Forrestfield North Residential Precinct Local Structure Plan**Submission Table**

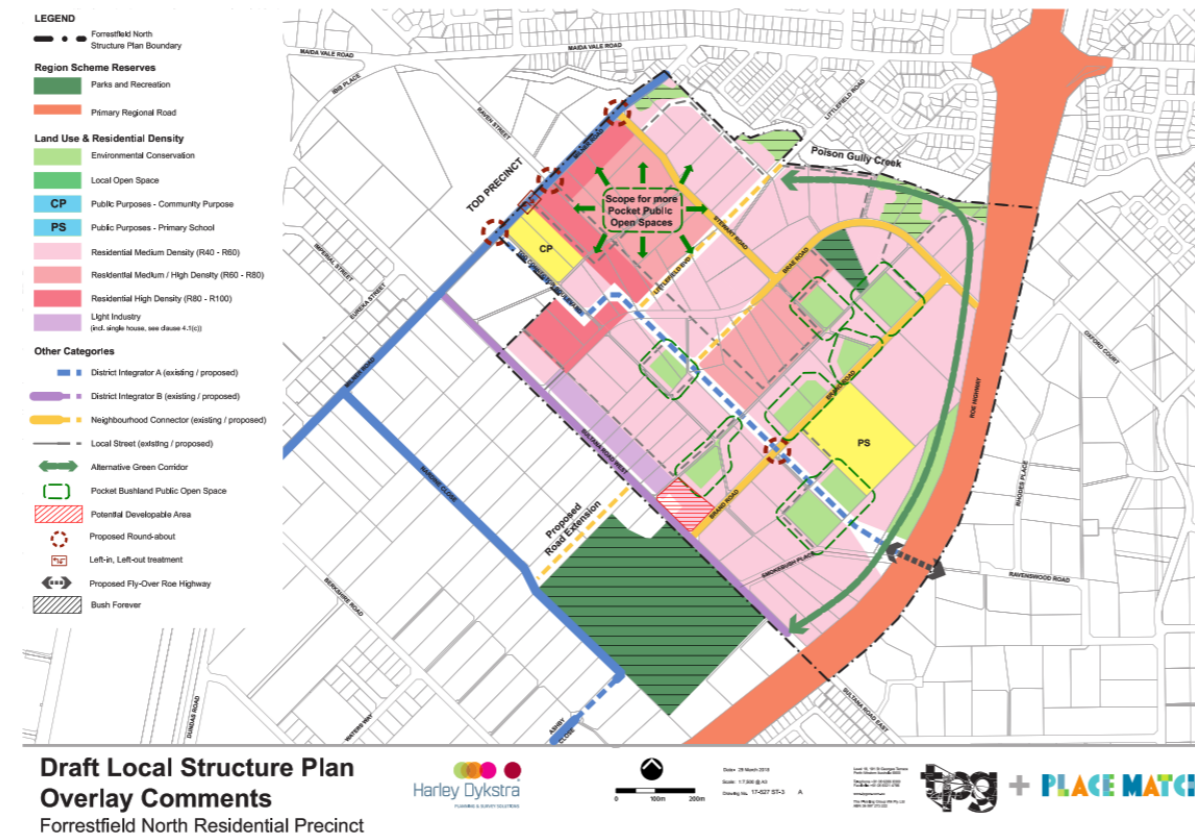
<p>That picture doesn't seem accurate as it makes it appear that the space available is very wide. As the services are on the south side, two extra lanes would mean resuming the footpaths and verges on the north side, which would encroach close to the residents' boundaries and prevent visitor parking. One section of Milner Road is very narrow near Maida Vale Road. I can't think how a dual carriage way could be implemented as there is little space for widening. The section of Poison Gully Creek over the bridge on the west side of Milner Road has been regenerated by a Friends' Group and is not listed as Bush Forever (it should be) but is important to the area. Building a dual carriage way on these roads would have a negative effect on the quality of life of the residents, of which I am one. No one wants to live on a very busy, noisy main road where there is heavy traffic and no visitor parking. The road is busy enough as it is (see photo below). It seems ludicrous to me, on one hand, to build a new section of town that will enhance the lifestyle of the residents while negatively affecting the lifestyle of other citizens living in the area. It would be more feasible to make Berkshire Road into the dual carriage way as it leads from Roe Highway to Dundas Road through an industrial area where no residents would be affected. Please take this suggestion into consideration.</p>
